# Technical Service Bulletin

## 94 Moisture accumulation in headlamps

94 13 01 2028277/5 January 2, 2013. Supersedes Technical Service Bulletin Group 94 number 12-98 dated November 21, 2012 for reasons listed below.

Model(s)	Year	VIN Range	Vehicle-Specific Equipment
Q7	2010-2014	All	Not Applicable

*Figure 2. Updated ventilation hose with integrated filter.*

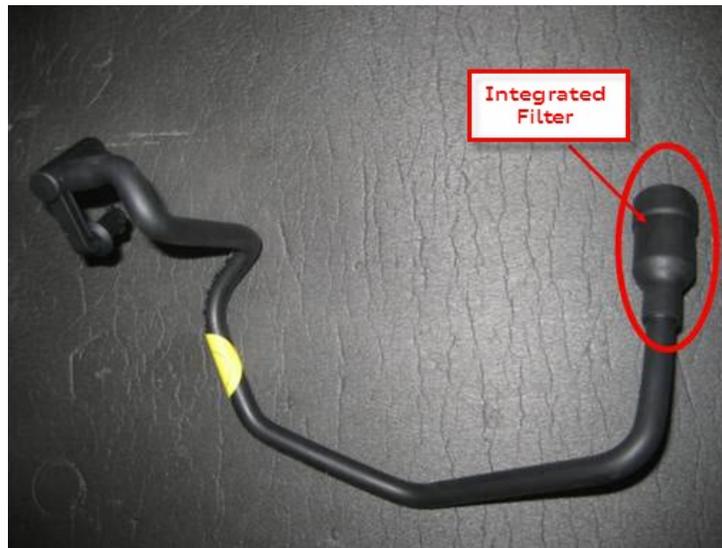
2. If vehicle's build is prior to VIN # \*CD004736, replace the headlamp ventilation hose for each headlamp with the new part number to help reduce any further humidity ingress into the headlamps (see Part information table below). Otherwise, move to step 3.

The updated ventilation hose can be recognized by the integrated filter (Figure 2).

*Figure 3. Butyl cord sealant, 10mm diameter.*

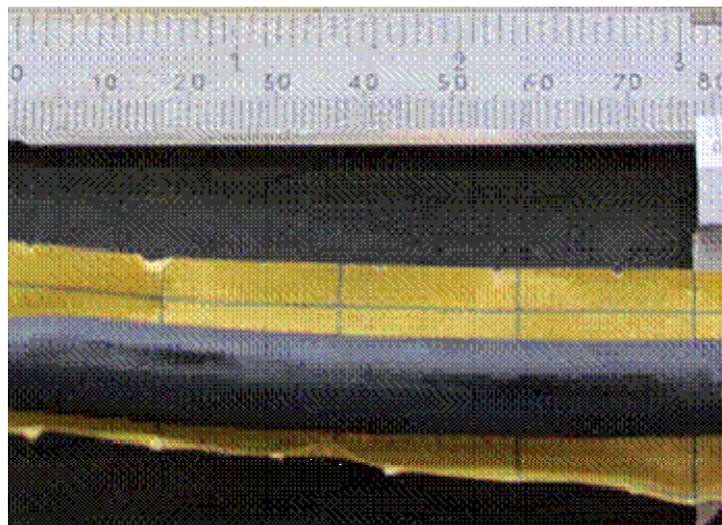
3. Cut two sections of butyl cord sealant, 8cm long each (Figure 3).

*Figure 4. Headlamp ventilation guide tube.*

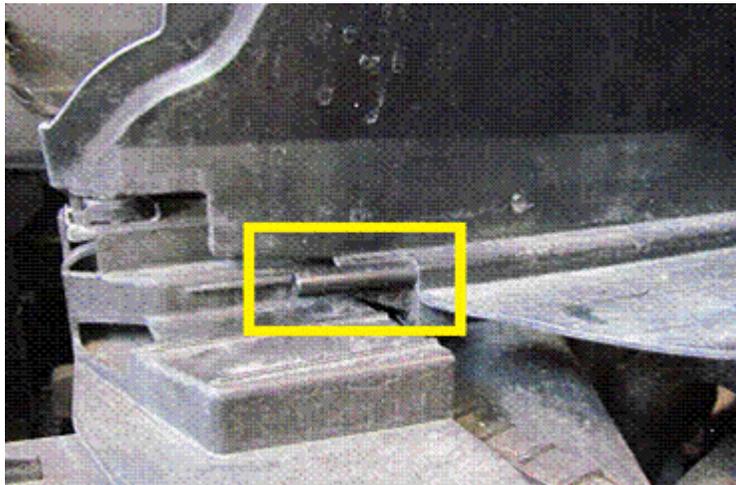
4. Each headlight ventilation guide tube must be sealed to protect against further moisture ingress (Figure 4).

*Figure 5. Initial butyl cord shown on guide tube.*

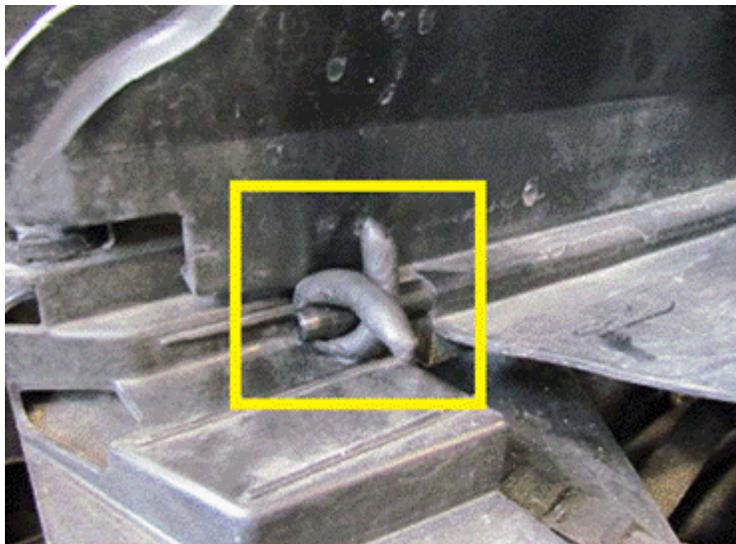
5. Wrap butyl cord sealant around the left and right ventilation tubes, taking care not to block the air passage tube (Figure 5).

*Figure 6. Butyl cord kneaded in place.*

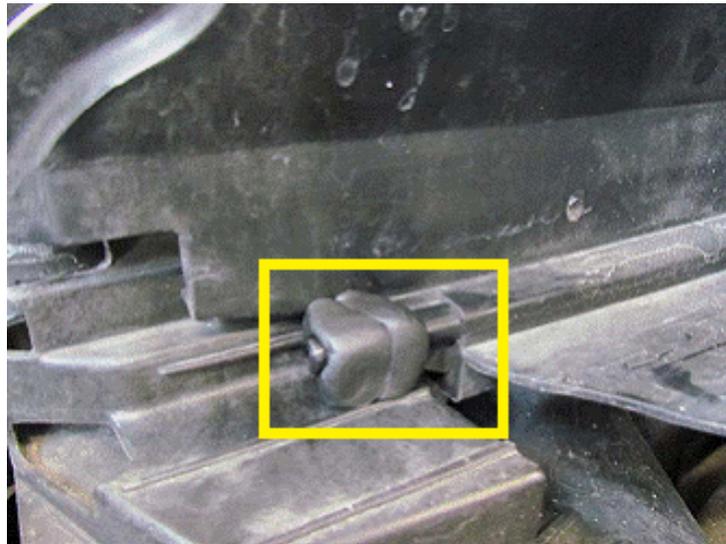
6. Knead the butyl cord sealant in place. The butyl sealant must be excessive enough so that the headlamp housing squeezes it and creates a robust seal at the housing (Figure 6).

*Figure 7. View of direction of headlamp engagement, with appropriate butyl cord application.*

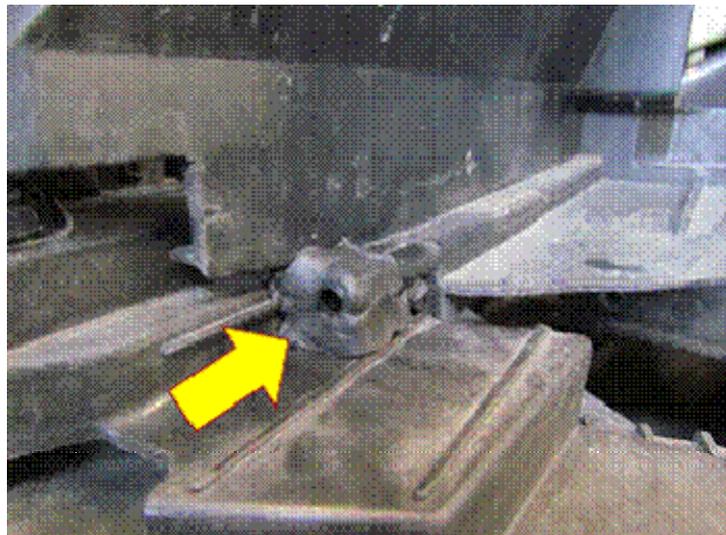
7. Leave an uncovered section of the air tube so that there is no chance the sealant will clog the air passage tube (Figure 7).
